SERVICE BULLETIN NZ SB142

Date: 26 May 2009

Units affected: All TM12 units built in New Zealand as per the list attached.

MANDATORY MODIFICATION

Fig 4. Location of front bolts [to be changed].

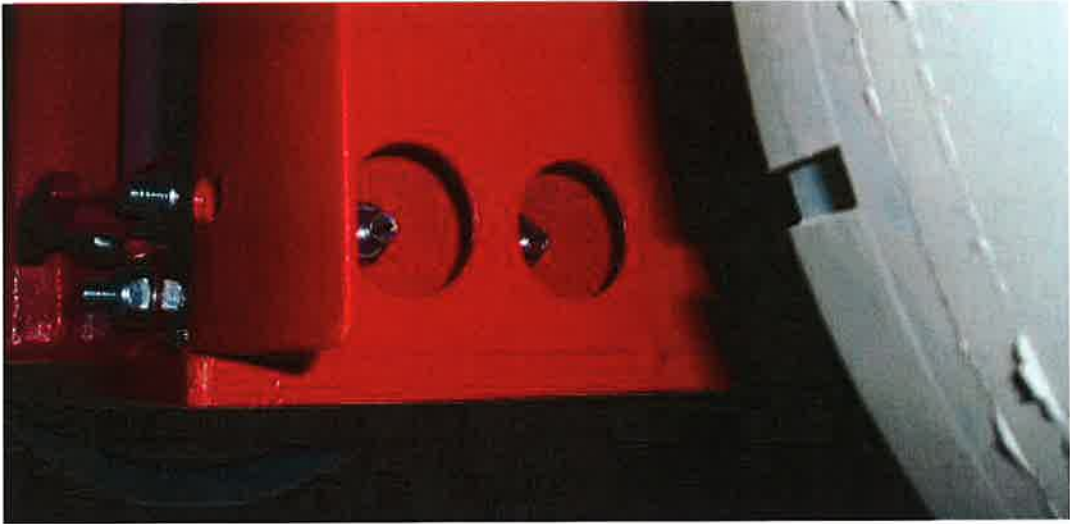
These machines have the incorrect grade of bolts fitted at the bottom of the mast assembly. These bolts must be replaced with a 10.9. grade not 8.8 which are currently fitted.

There are a total of 11 bolts at the bottom of the mast assembly however this procedure requires that only 9 of them are to be replaced.

The bolts at the rear on either side will remain GR8.8 [refer to fig 2].

The new bolts are part # 3616-10030, the new nut is part # 13323-10. These items will be supplied by Snorkel free of charge.

Remove and replace the bolts one at a time, note that the new GR10.9 bolts must be done up to a torque setting of 69Nm [50lbft].

Fig. 5 Access to the side bolts can be gained through the holes in the side of the chassis.

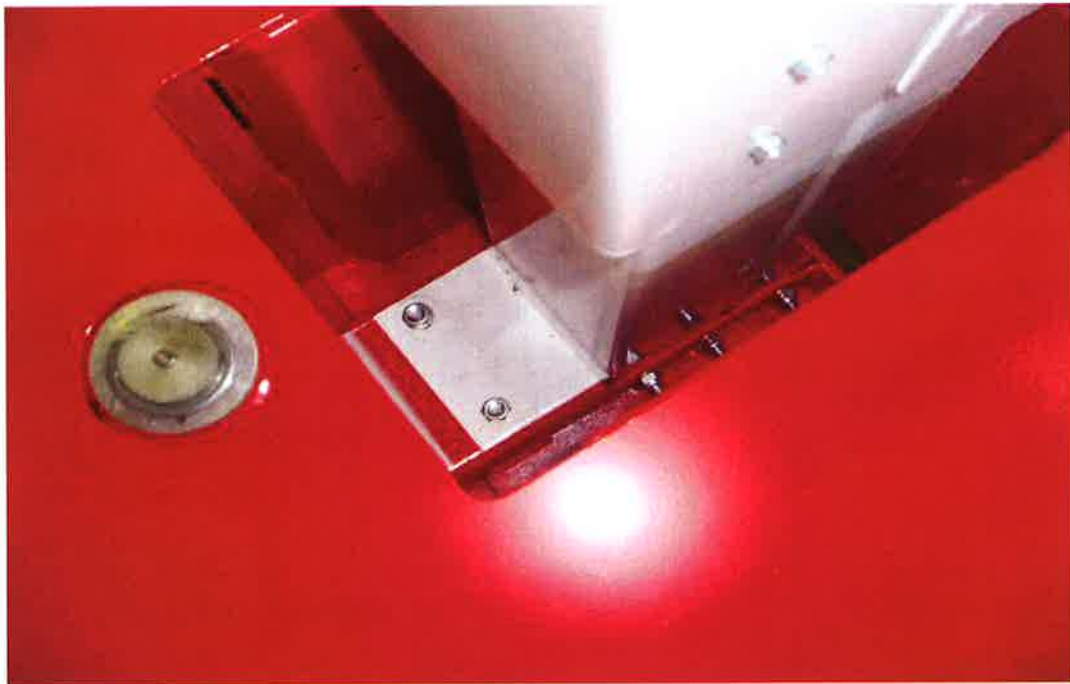
In order to gain access to the bolts it will be necessary to remove the front cover and raise the platform up.
